SECY-98-274

SUBJECT: COMMONWEALTH EDISON COMPANY'S PROPOSAL TO CENTRALIZE ITS
EMERGENCY OPERATIONS FACILITIES AT ITS CORPORATE OFFICES

To obtain Commission approval of the proposal by Commonwealth Edison Company to replace its four nearsite emergency operations facilities with a centralized emergency operations facility.

FIGURE 4.3-1
THE CEOF ORGANIZATION

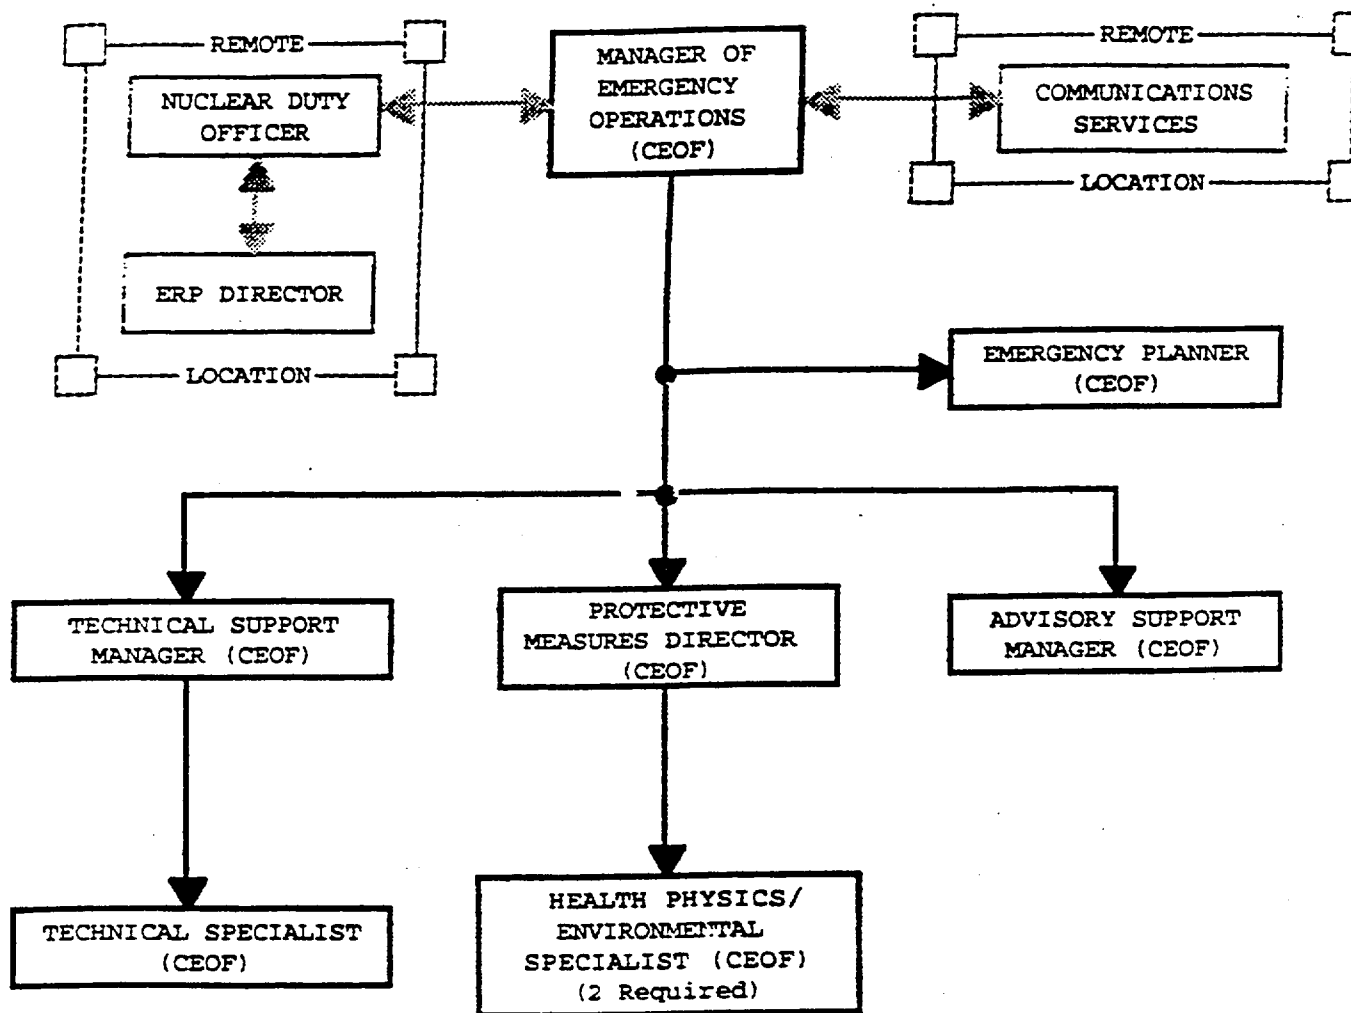
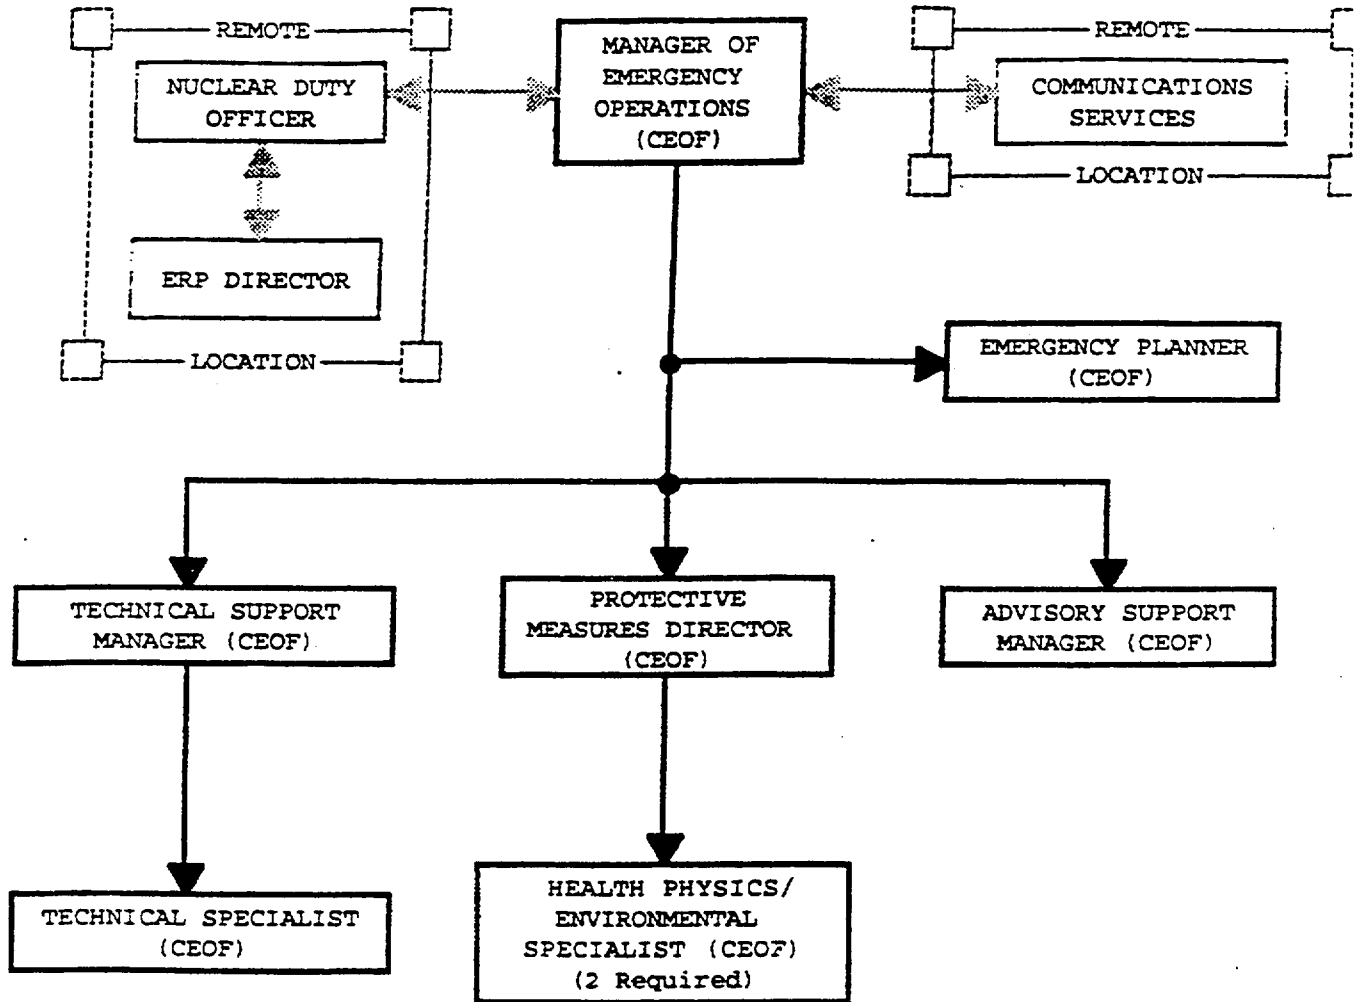
- o Direct the CEOF Organization shown in Figure 4.3-1 and coordinate all CECO activities involved in coping with the emergency, ~~determine staffing needs as appropriate.~~
- o ~~Approve the technical content of CECO press releases prior to their being released to the media. Coordinate CECO press releases with the Nuclear Duty Officer and Communications Services, as appropriate.~~
- o Request assistance from non-CECO emergency response organizations, as required.
- o ~~Evaluate the need, based on events in progress, to staff the EOF to provide additional support to the Station.~~
- o Maintain a record of the GSEP related activities.

- o Remain at the CEOF and provide assistance to the ~~Station Director and~~ Station Director and Manager of Emergency Operations (EOP), as requested.
- ~~o Direct the CEOF Organization shown in Figure 4.3-1.~~
- ~~o Maintain a record of GSEP related activities.~~

- o Direct the CEOF Organization shown in Figure 4.3-1 and coordinate all CECO activities involved in coping with the emergency.
- o Coordinate CECO press releases with the Nuclear Duty Officer and Communications Services, as appropriate.
- o Request assistance from non-CECO emergency response organizations, as required.
- o Evaluate the need, based on events in progress, to staff the EOF to provide additional support to the Station.
- o Maintain a record of the GSEP related activities.
